# SONY® Service Bulletin

NO: CTV-98-001

**SUBJECT:** VERTICAL JITTER; R504 AND/OR R521 DAMAGED

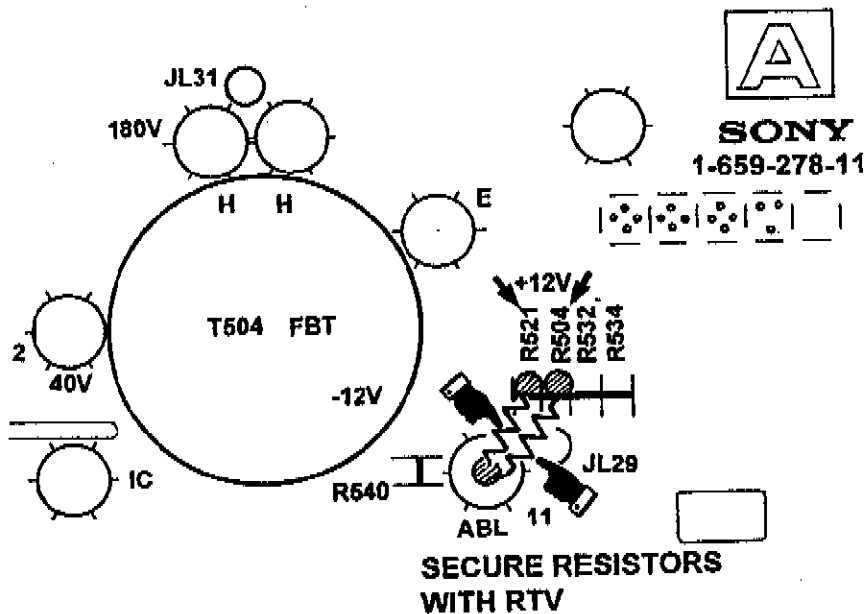
**Symptom:** The picture exhibits vertical jitter. This problem may occur if R504 and/or R521 are damaged.

**Solution:** If the above symptom is found to be caused by damaged R504 and/or R521 on the A-board, replace both resistors with the parts shown below.

REF	FORMER		NEW	
	DESCRIPTION	PART NUMBER	DESCRIPTION	PART NUMBER
R504,R521	RESISTOR, 10K, SURFACE MOUNT, 1/10W	1-216-073-00	RESISTOR, 10K, LEAD TYPE, 1/4W	1-249-429-11

**SUBJECT: PREVENTING DAMAGE TO A-BOARD DURING SERVICING**

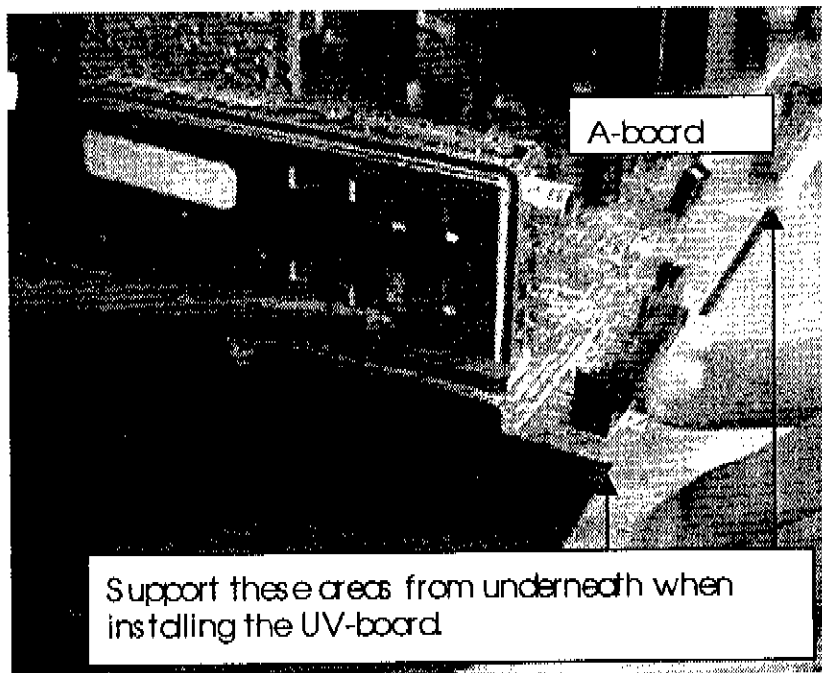
**Symptom:** The rear portion of the A-board extends beyond the circuit board support rails of the front cabinet. Consequently, cracked or broken solder joints, lifted lands, or board breakage may occur if pressure is applied to the rear portion of the A-board during servicing. This is especially true when installing the UV-board onto the A-board, which may result in the aforementioned damage in the area of the tuner.

**Solution:** Prevent A-board damage by carefully handling the board during servicing. Be sure to support the A-board from the underside when installing the UV board to prevent any undue stressing of the A-board.

**SUBJECT: NEW TUNER REPLACEMENT**

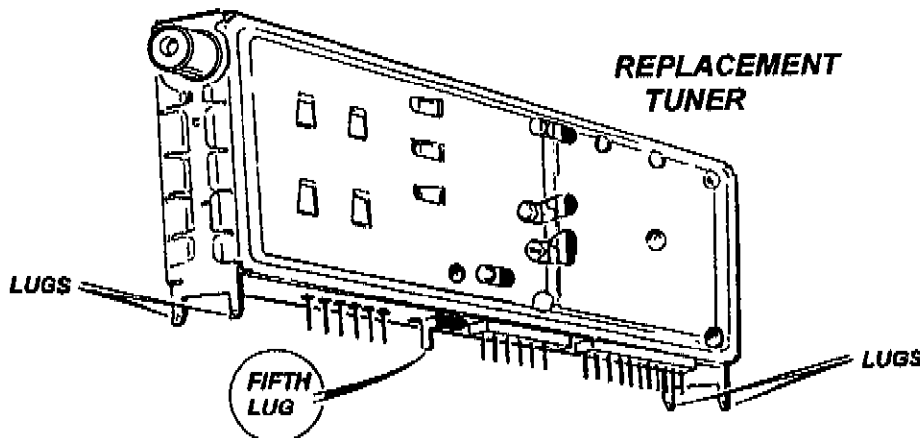
**Symptom:** New replacement tuner has five ground lugs compared to four on the original tuner. Board does not have a hole to accommodate the fifth lug.

**Solution:** When replacing the tuner with the new replacement tuner it will become necessary to remove the fifth lug, located in the middle of the tuner.

**A BOARD SCHEMATIC GRID LOCATION L-20**

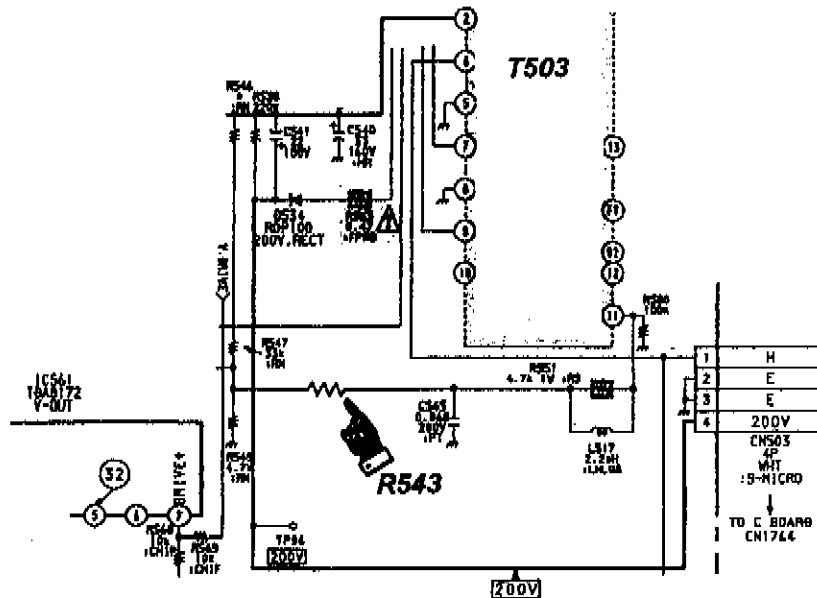
**Symptom:** The part number for Ref # R543, 0.47 Ohm 1/4W, located on the A board, was not shown in the schematic or listed in the parts list.

**Solution:** Please add the following part number to the Service Manual.

REF	DESCRIPTION	PART NUMBER
R543	0.47 OHM 1/4W	1-249-377-11
